## Proposal for amendments to ECE/TRANS/WP.29/GRVA/2019/9

The text reproduced below was prepared by the expert of Germany on the basis of the working document GRVA/2019/9, which was submitted by the by the expert from France. Modifications are marked in **bold green** for new or ~~green strikethrough~~ for deleted characters.

Figure 1  
Lateral Acceleration Filtering: Comparison of tests led on 4 vehicles in the same curve

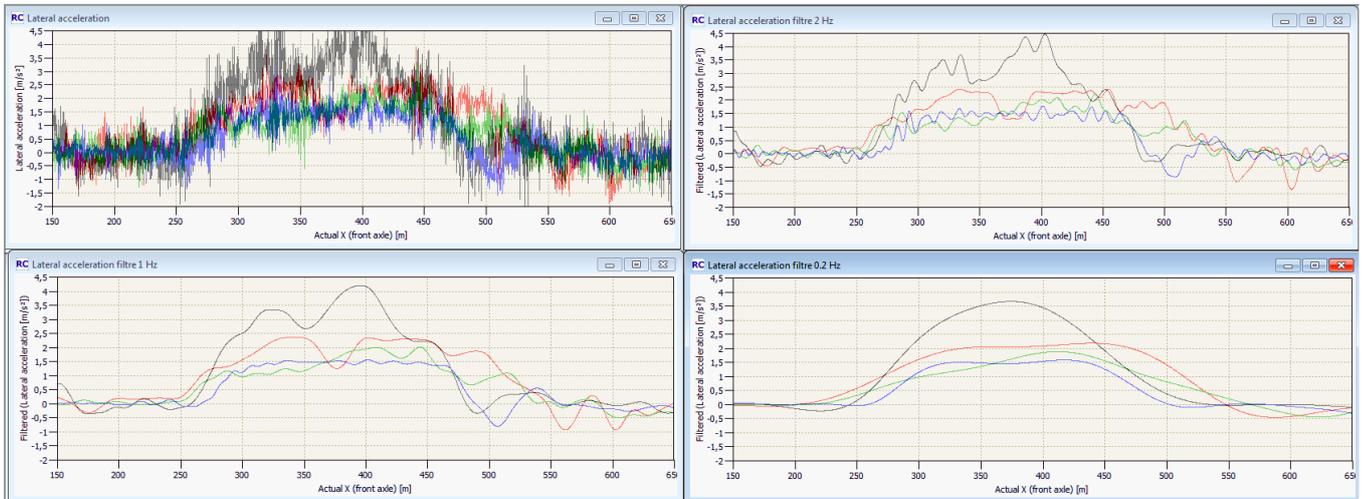
1. For keeping a traceability, it could be interesting to indicate in the report both the position at which the lateral acceleration was measured and the position of the centre of gravity of the vehicle.
2. For dynamical tests the usual value of sampling rate is at least 100 Hz.
3. The figures below show the shapes of the lateral acceleration signals versus the value of the cut-off frequency: No filter, filter at 2Hz, filter at 1 Hz and filter at 0.2 Hz.
4. The results show that the best representation of the dynamical behavior is obtained when the used filter is 1Hz.

- Quadrant 1 shows the raw data (no filtered)
- Quadrant 2 shows the signal filtered at 2Hz
- Quadrant 3 shows the signal filtered at 1Hz
- Quadrant 4 shows the signal filtered at 0.2hz.

**To determine the lateral acceleration, the raw data shall be filtered by applying a fourth order Butterworth filter with a cut-off frequency of 1Hz.**

Figure 2  
**Lateral Acceleration Filtering: Comparison between the 2 proposals for a vehicle near the limits**

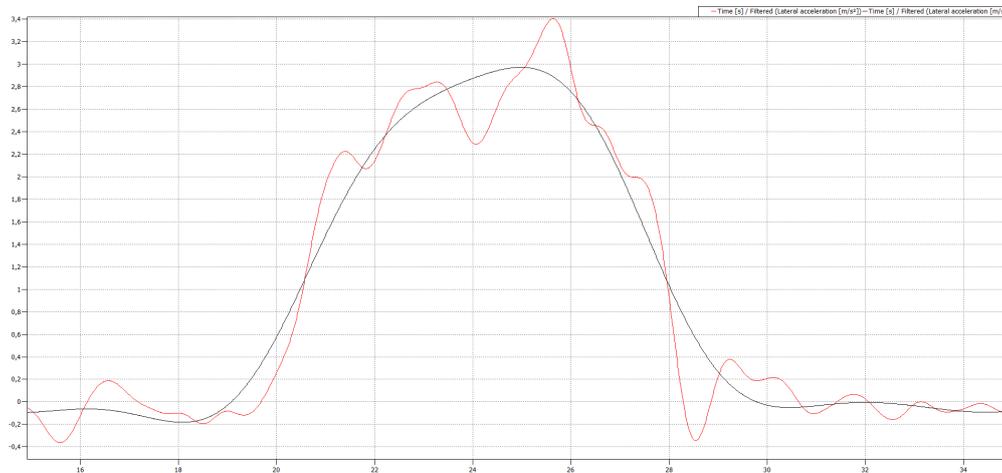
Blue line (0.2hz) and red line (1 Hz) as proposed in this document. In the first case the vehicle passes the test (Maximum value: 3 m/s<sup>2</sup>) while in the second case the vehicle fails the test (maximum value: 3.4m/s<sup>2</sup>).

**When introducing filtering in Annex 8 it has to be ensured that noise, transitional overshooting issues or the filtering itself do not influence the test result. Introducing a filter with a cutoff frequency of 1 Hz makes it at the same time necessary to specify other tolerances in the Regulation for the lateral acceleration, so that the thresholds for the lateral acceleration can be exceeded for short time periods. This is done in paragraph 5.6.2.1.1. of the Regulation.**

**Irrespective of the values specified in the table in paragraph 5.6.2.1.3. of this Regulation, the lateral acceleration of the system may exceed the specified value  $a_{y_{\text{max}}}$  by not more than  $1.5 \text{ m/s}^2$  for a limited time period of not more than 2 s within a rolling interval of 4 s."**
